SANDY CITY COMMUNITY DEVELOPMENT

MEMORANDUM

To: Planning Commission
From: Community Development Department
Subject: American Loans Office – Architectural Design Exception SPR-02-20-5810 Approx.
Request for a Modification of the 20 Percent Limit on 0.62 Acres
Stucco Exterior Building Material Use RC Zone
8800 South Harrison Street
[Community #1, Northern Exposure]

NORTH ELEVATION

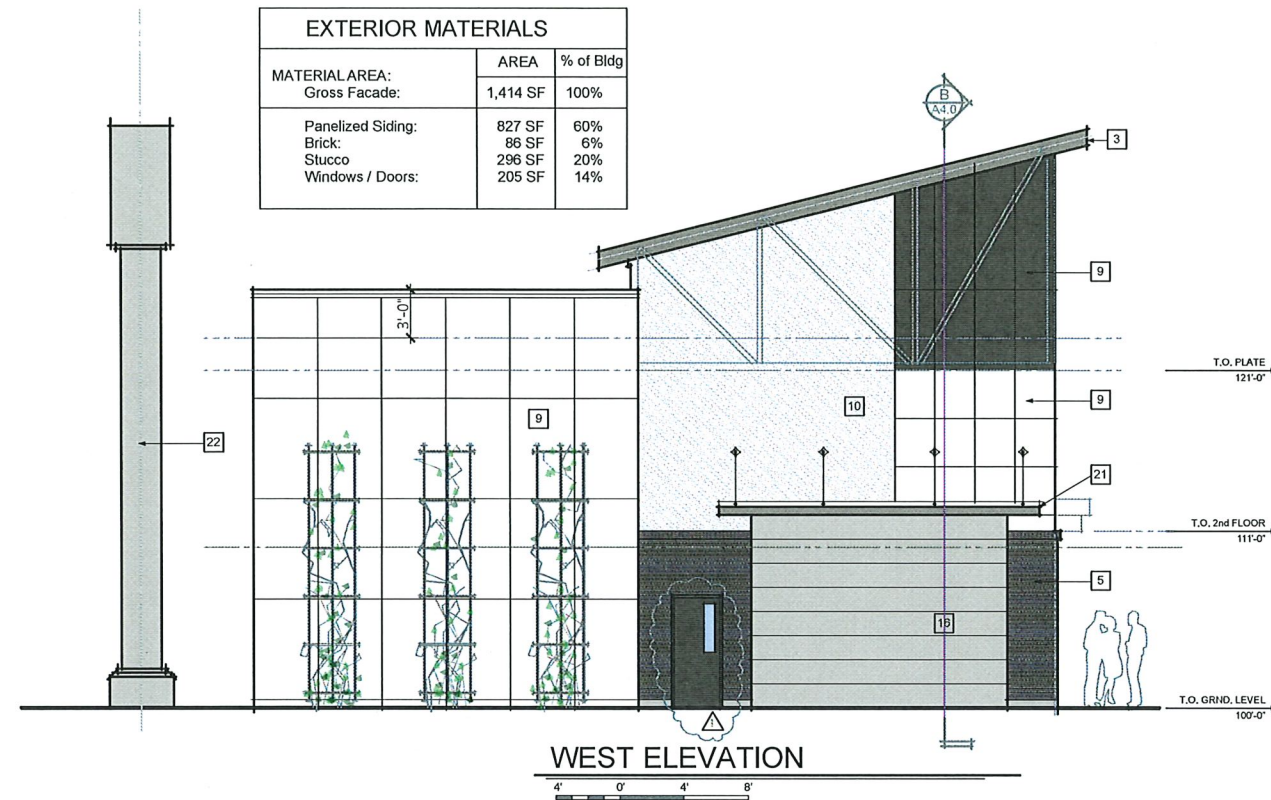
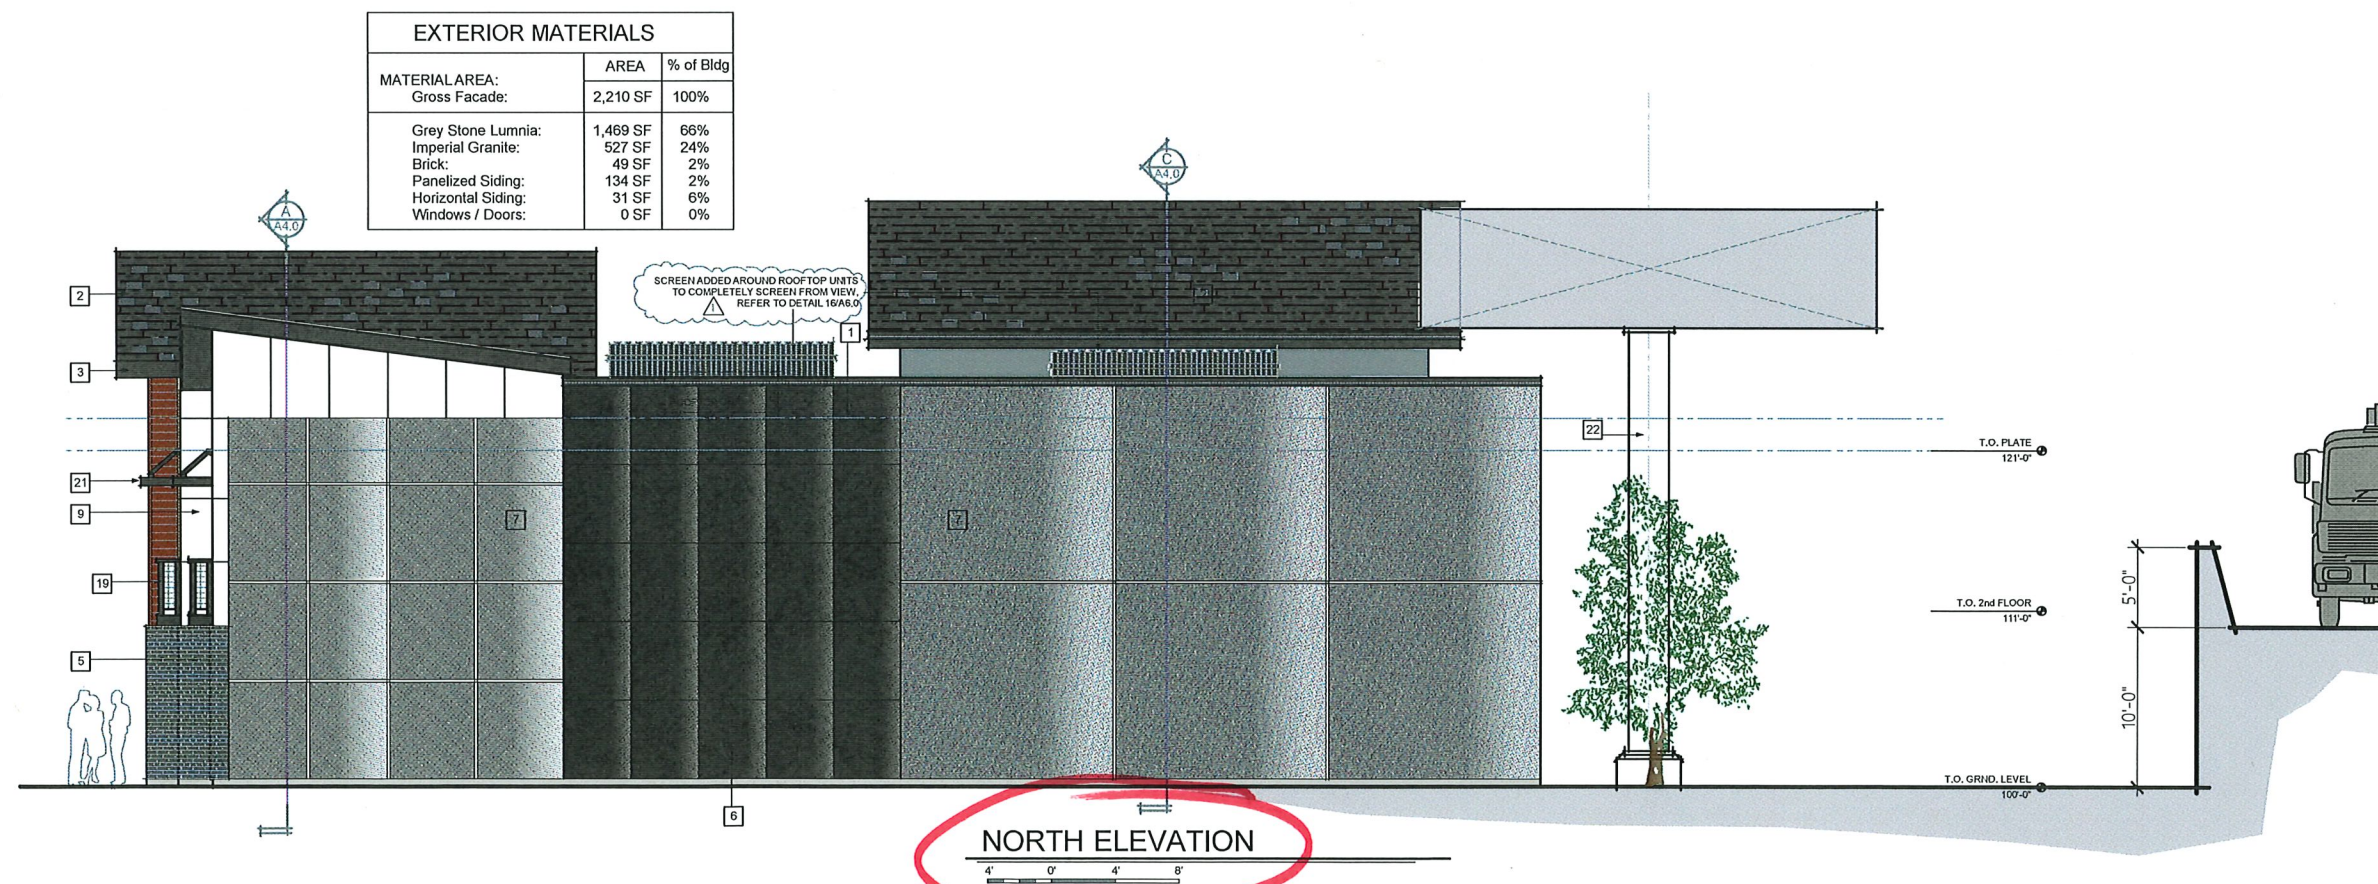
The result is that now the “Terra Neo type” materials has been installed on the north wall of the north building, but without sufficient small scale scoring on the lighter color panels on either side of the darker colored central panel, which was initially scored in smaller scale. Presented with this issue, the Architect, Jim Darling suggested that to increase the density of the scoring on the two lighter material panels, that architectural aluminum strips be applied in a grid pattern to the top of the “Terra Neo type” material, to give the appearance of additional scoring density. This is what is now being presented to the Planning Commission for consideration.

Requested exception. The applicants are now requesting that the Planning Commission consider the proposed application of “Terra Neo type” stucco topcoat material to 90 percent of the north building’s north wall surface area and approve the use of the proposed aluminum strips to be applied to the two light colored portions of the wall in the grid patterns as shown, to increase the off-site appearance of scoring density, to help give a stone panel application appearance.

Staff recommends that the Planning Commission find that the requested use of “Terra Neo type” stucco material on 90 percent of the north wall of the north building on the site at 8800 S. Harrison Street be approved as proposed with the aluminum strips being added to increase the appearance of scoring density as represented in the new building elevation drawing details, based upon the following three findings and the following one condition:

1. That the project be completed expeditiously now and that no further changes to the building, site plan or any other details, without pre-approval by City Planning staff or Planning Commission, as may be required by City ordinance or administration.
